Clepa contributions for frontal, rear and side impacts are highlighted in blue colour and in italic characters. Clepa contribution focuses on Phase 1 of the new regulation, therefore most of requirements or definitions related to belted CRSs were deleted. Therefore we concentrate here on Isofix Integral Universal products.

E/ECE/324 } Draft Reg. for iSize CRS
 E/ECE/TRANS/505 } Version 05 October 2009
 page 7 } Frontal, rear and Lateral impact

Figure 1

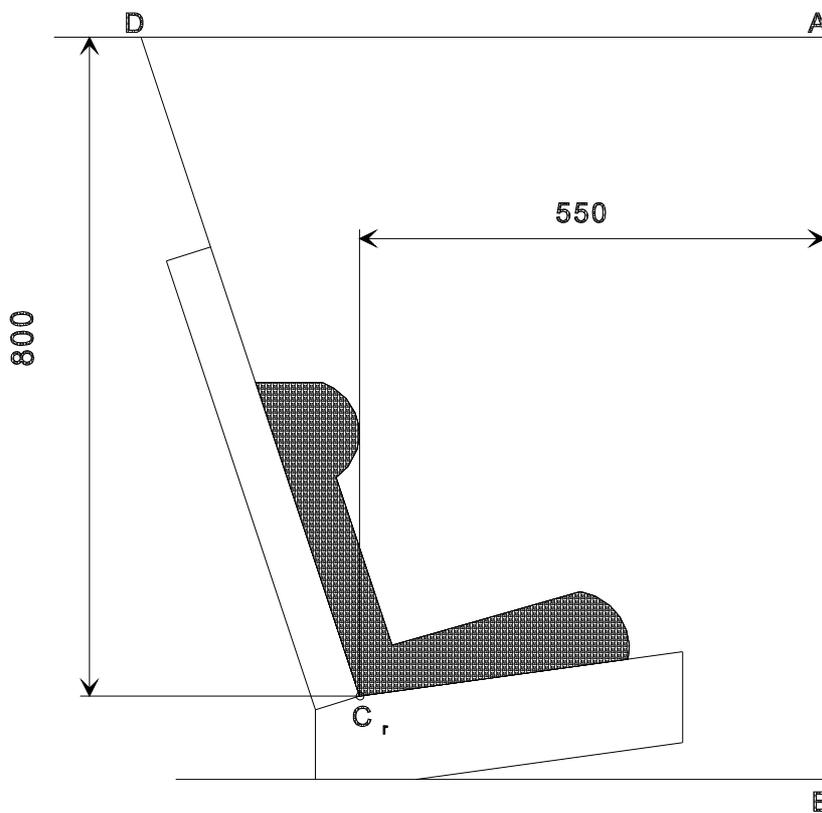
Remark: as is the case with rearward facing child restraints, the point E being the top of the seat back of the R.44 seat should also be defined here.

Furthermore, because it concerns ISOFIX child restraints, the forward excursion limit shall have to be changed from 550 mm to 500 mm.

Remark The 500 mm head X excursion is compatible with R44/04 dummy performance

criteria such as chest acceleration. Maintaining the same limit with products that have to pass more demanding criteria such as neck loads criteria will be a very difficult task. That compatibility has to be checked before adopting injury criteria.

Finally, the 800 mm vertical limit shall have to be connected to only testing with Q0, Q1, Q1.5, Q3 and Q6, whilst for testing with Q10 a vertical limit of 840 mm will be used.

Figure 2:
Arrangement for testing
a rearward-facing device

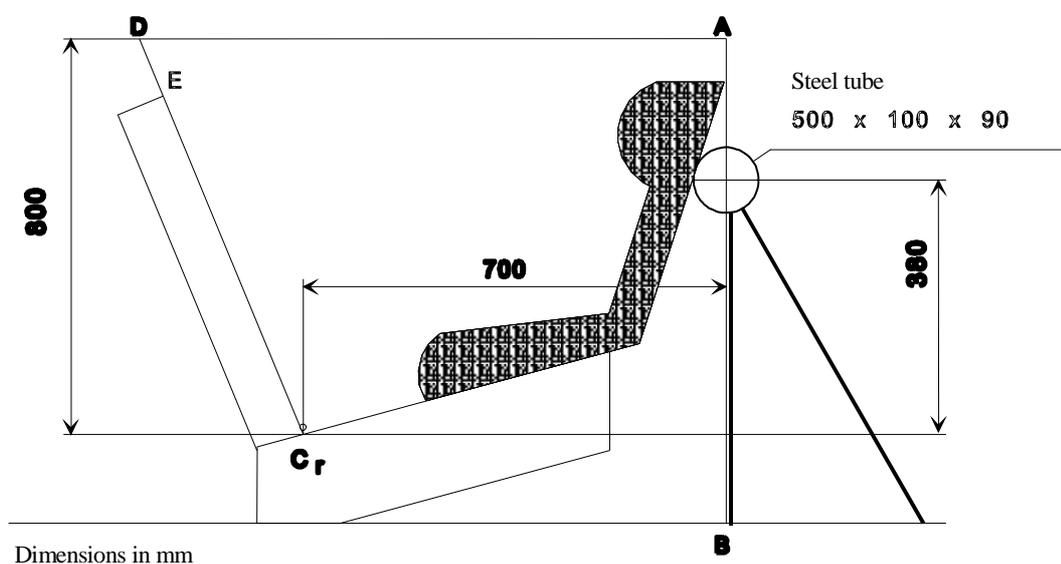
Remark: figure below with support by dashboard not needed anymore must be deleted

Figure 3

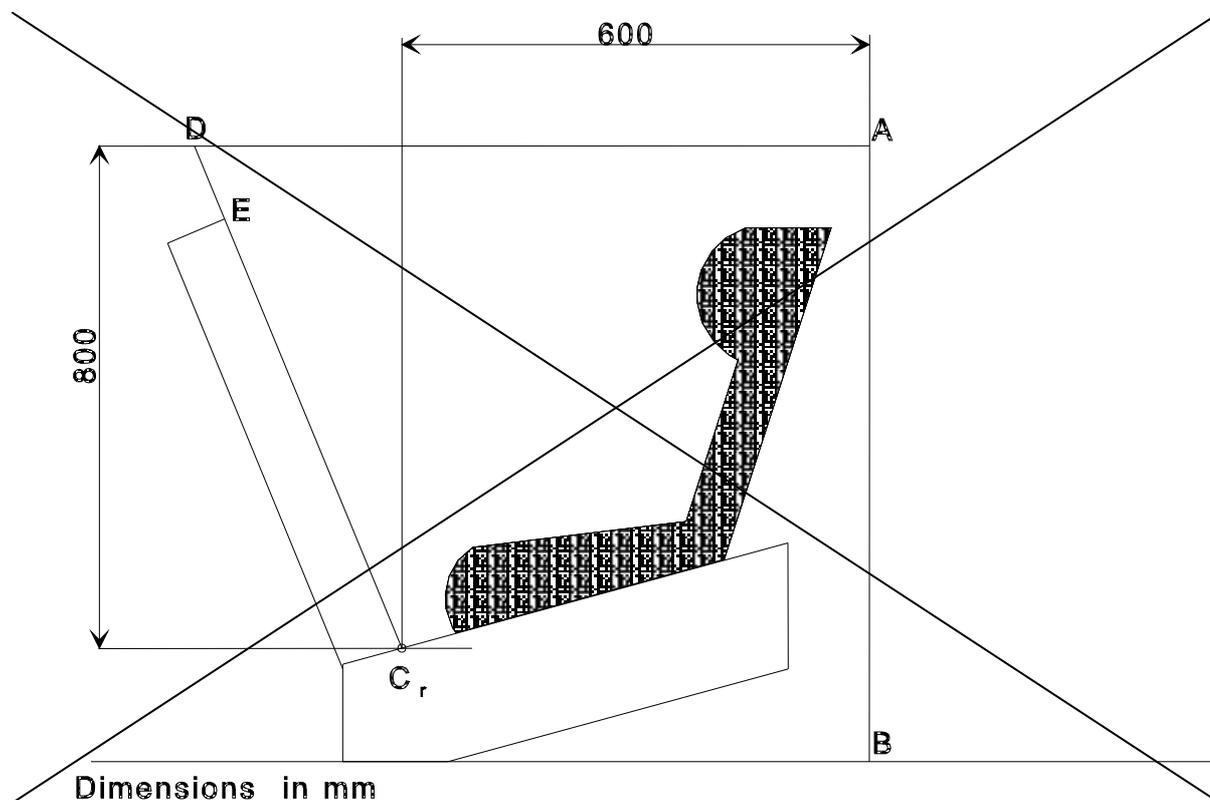
Remark: figure below with distance of 600 not needed anymore must be deleted

Figure 4:

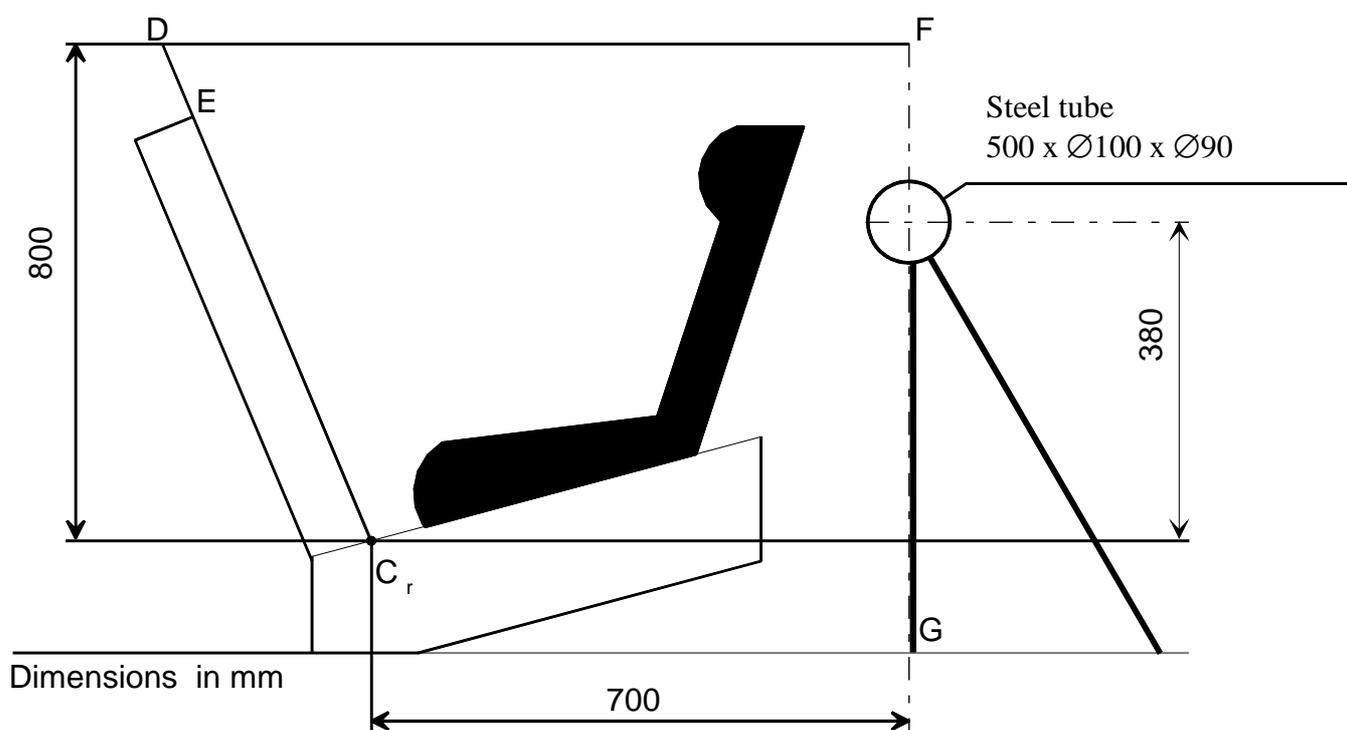
Remark: now from the point of view that a distance from Cr point to dashboard of 700 mm will be an accepted measure, it should be safeguarded that front passenger car seats can offer this space (after normal adjustment of the seat).

**CURVE OF RELATIVE VELOCITY BETWEEN TROLLEY AND DOOR PANEL
AS FUNCTION OF TIME**

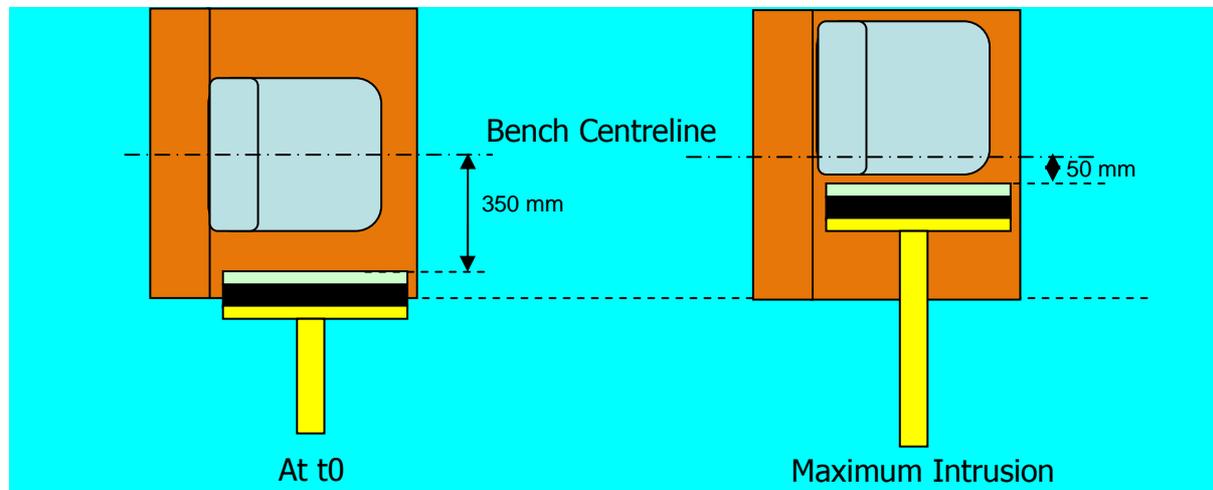
Remark: The corridor must be defined on experiences of respective test labs.
